**AMENDMENTS TO THE DRAWINGS:**

## REMARKS

Fig. 8.

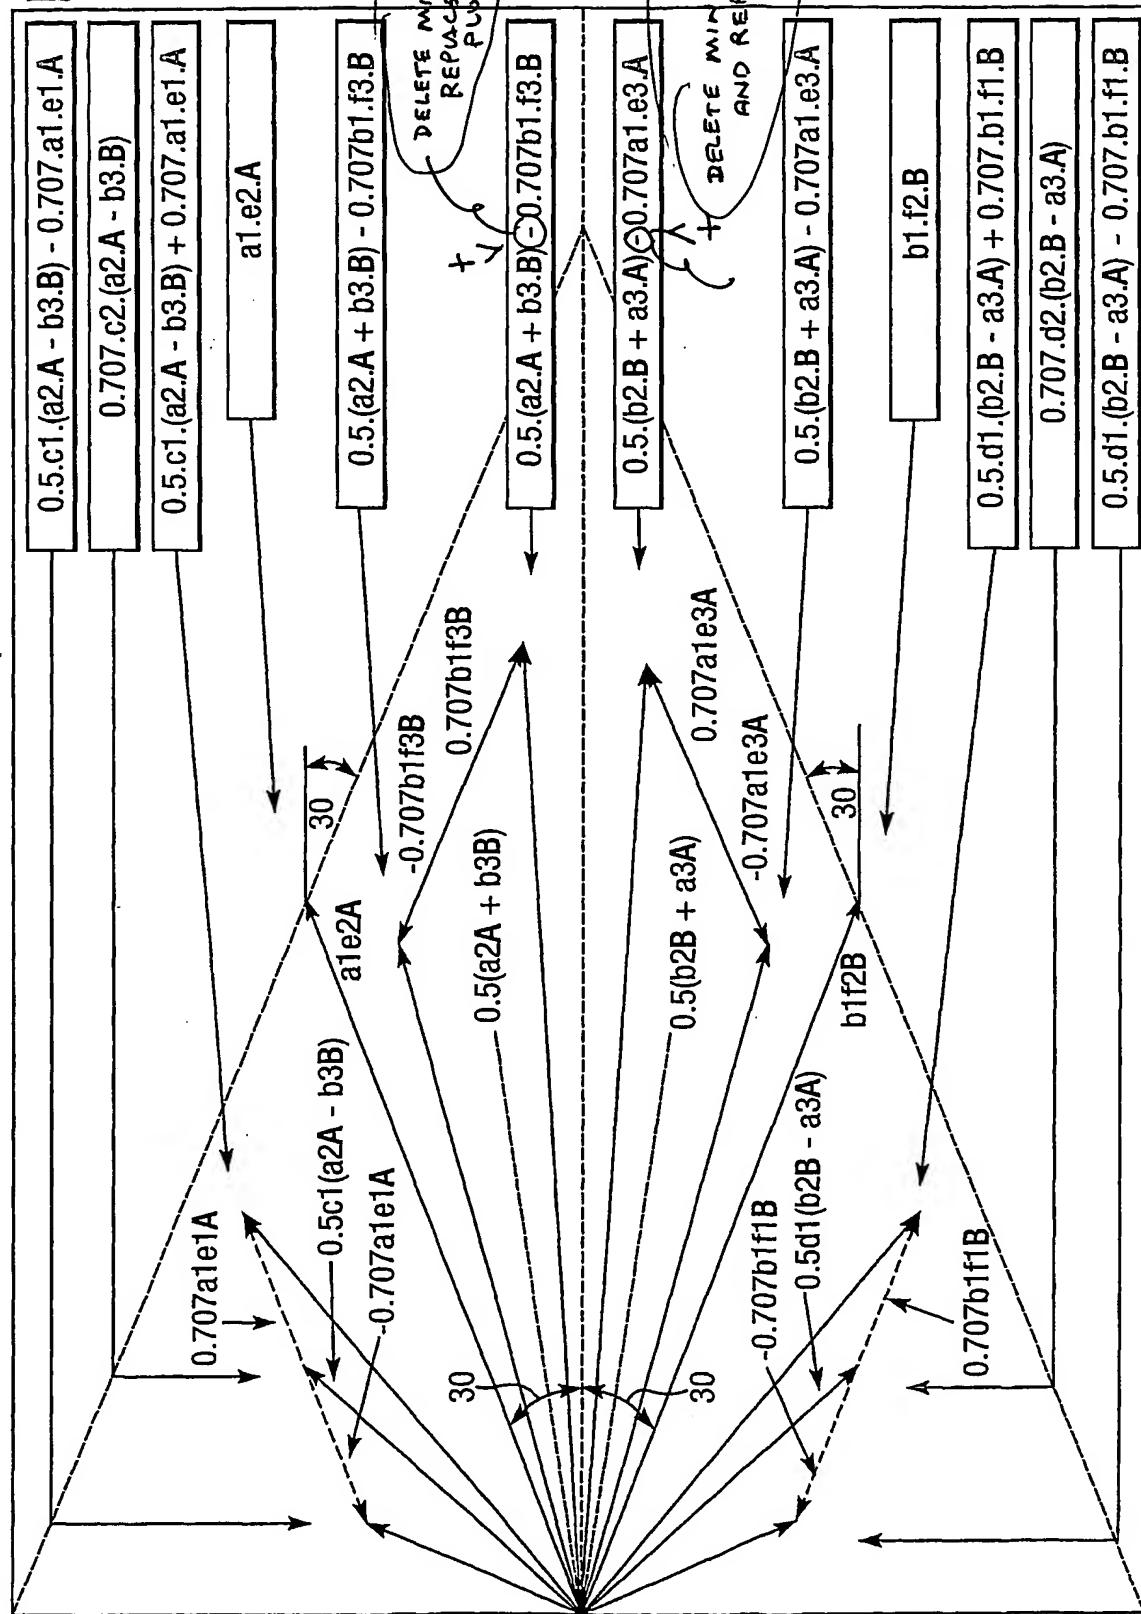
The attached drawing sheets include amended and marked-up versions of Figure 8. Figure 8 has been amended to change several minus (-) signs to plus (+) signs.

Figure 8 is amended in two instances to change minus signs (“-“) to plus signs (“+”). This amendment is supported by vector diagrams (arrows indicating vectors in magnitude and direction) adjacent to the left side of the amended Figure 8 boxes, which show 0.707b1f3B being added to 0.5(a2A + b3B) and 0.707a1e3A being added to 0.5(b2B + a3A) respectively. Additional support for this amendment is found in the specification and figures.
